Dam Safety Section

INTEROFFICE MEMORANDUM

SUBJECT: Grossen Creek Impoundment

RE: Grossen Creek Dam

Figure 3 (6-5-09) - View looking east from the Cenex parking lot, upstream toward the existing dam. Along the distant fence-line is a 2-ft high berm that would serve to divert water resulting from a dam failure north toward Grossen Creek, or south into a smaller drainage adjacent to a subdivision.

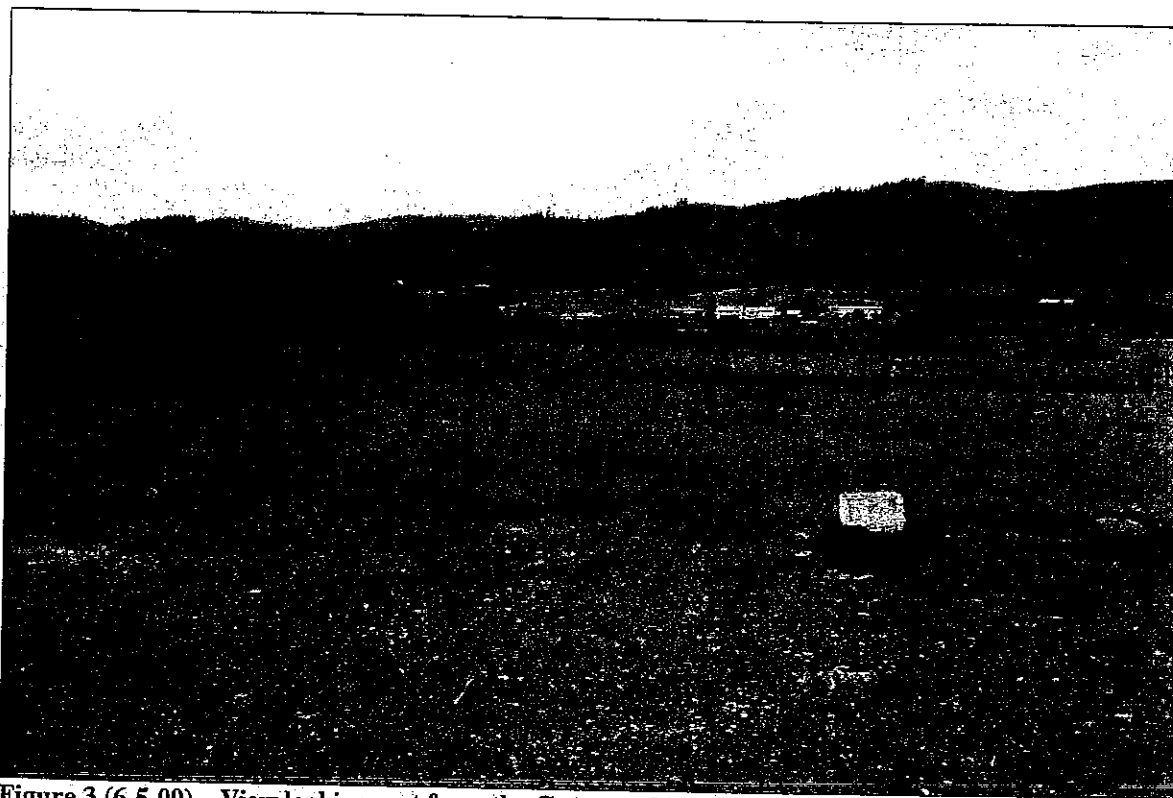
I totally disagree that a 2ft high berm is adequate to safeguard the Cenex gas station and Highway 95 from a Dam break
